**Our Ref: SS279**

## **REPORT ON ATTIC BRICKWORK REPAIRS TOWN HALL, FELIXSTOWE**

***LEFT CHIMNEY.***

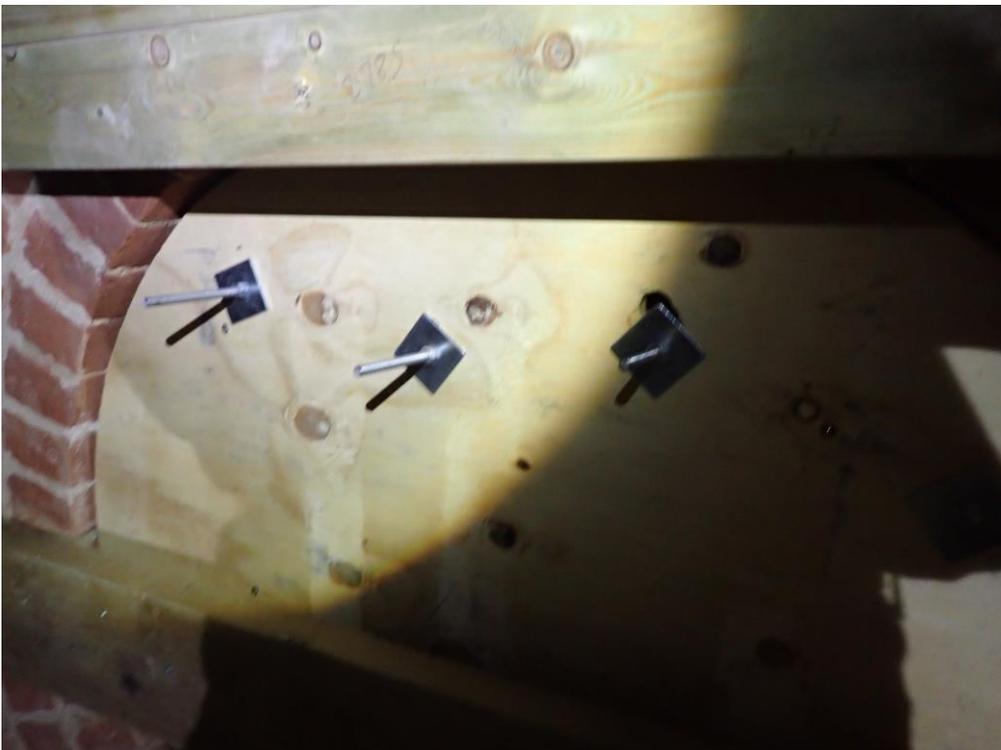
- 3.1.2 The chimney to the left-hand side has been satisfactorily repaired.
- 3.1.3 The right-hand side chimney has had the two levels of Helifix bars installed within the horizontal mortar beds. Brickwork had been replaced where damage and defective mortar beds have been repointed or replaced.
- 3.1.4 In a similar way to the above the three brick courses below the wallplate to the front and front part of the right-hand elevation had been replaced where the brickwork was damaged and repointed where the brickwork was still sound.
